**BLANKET V070-361995 (LH & RH) MAY
INTERFERE WITH PVD PURGE VENT
ON XO 378**

Element/End Item: **OV-103**
Flow/Usage: **116/FLIGHT 33**
Facility: **OPF-3**
Design Center Concurrence: **KSC**
Category:
OPR: **TCS**
TTL ORG: **TO**

Approval Record

Figure 11-2 Boroscope view of LH Xo 378 purge vent (IPR 116V-0015)

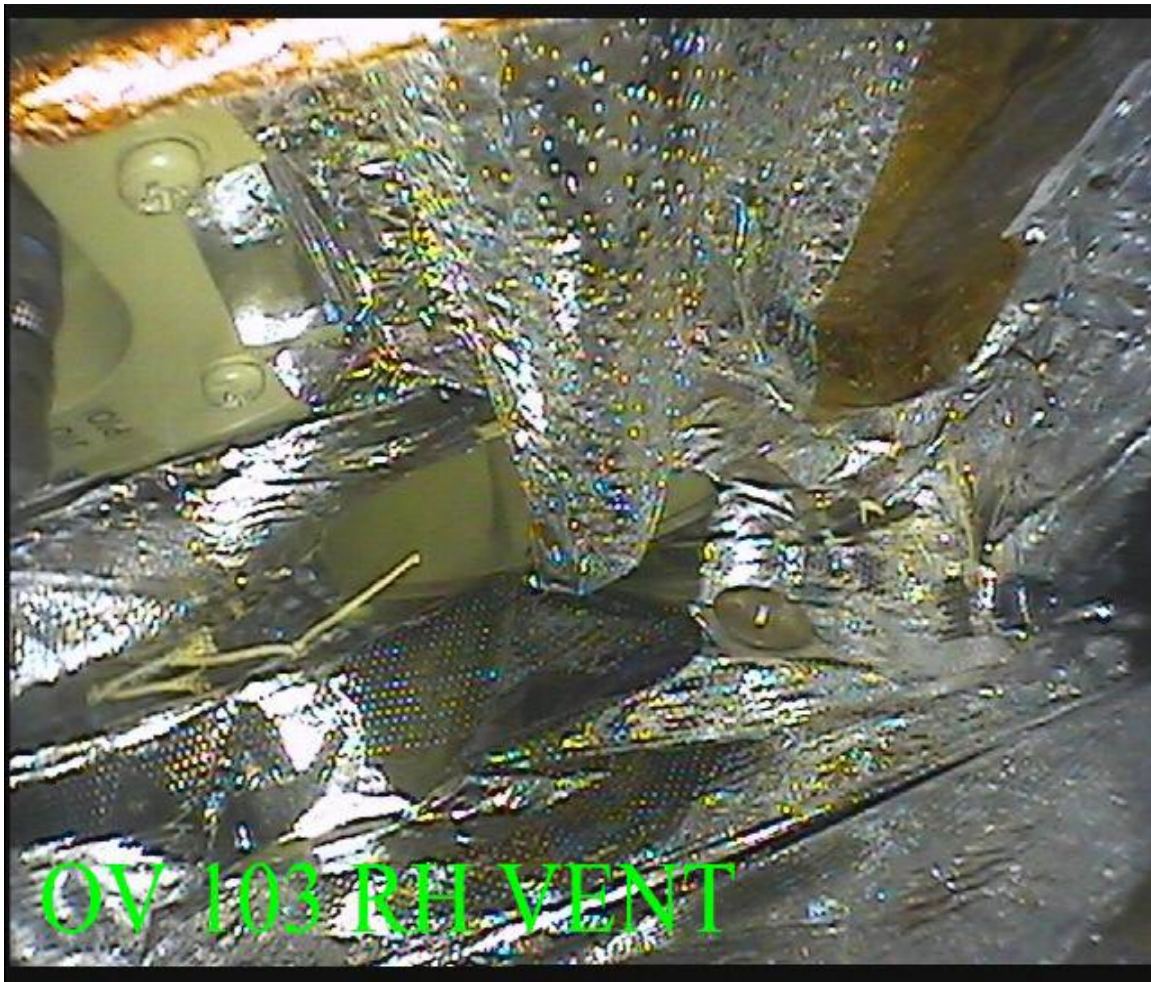
Note: Flow path obstructed by blanket.

Problem Description: Suspect Condition: Blanket V070-361995 (LH & RH) may interfere with PVD purge vent on Xo 378.

Engineering Interim Summary: During STS-121 ascent, the Xo 378 bulkhead delta-pressure transducer showed higher than normal pressure differential across the bulkhead. This was documented as an IFA (ref IPR 116V-0015). The actual pressure differential encountered was 1.2 psi. The structure is certified to .95 psid. Blockage of the Xo 378 purge vents from the FRCS side was considered the most likely cause.

- install under drain lines
- tie to thruster box blankets using lacing cord and buttons
- tape to thruster box blankets along inboard seams

On FRC3 the blankets were reworked and repositioned as recommended above. Blankets were installed under drain lines, fastened to thruster box blankets with buttons and tie

Figure 11-4 Boroscope view of LH Xo 378 purge vent after repositioning of blanket (SPC # 90790)

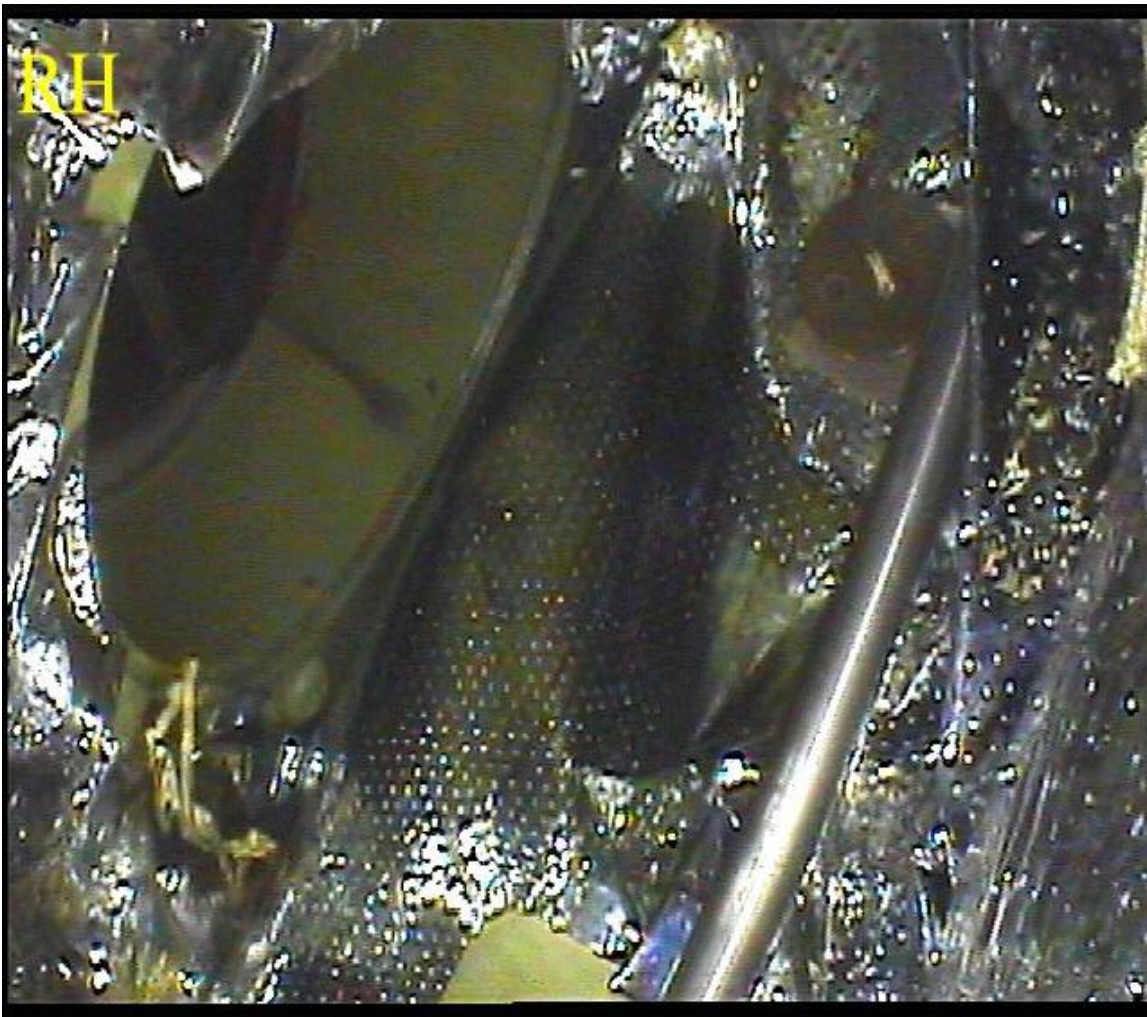
Note: MLI Blanket under drain line and secure to adjacent blanket. Flow path no longer obstructed by blanket.

FRC3 blankets were reworked and repositioned to eliminate the interference with the Xo 378 vents and prevent any possibility of billowing. Blankets were installed under drain lines as per design intent, fastened to thruster box blankets with buttons and tie cord per drawing, and taped to thruster box blankets along inboard seams with approved TCS tape. Post rework borescope photos show no obstruction to purge vent operations for STS-116. The blanket rework was evaluated and approved by Boeing, USA and NASA TCS, PVD and STR engineering groups, at both KSC and JSC.
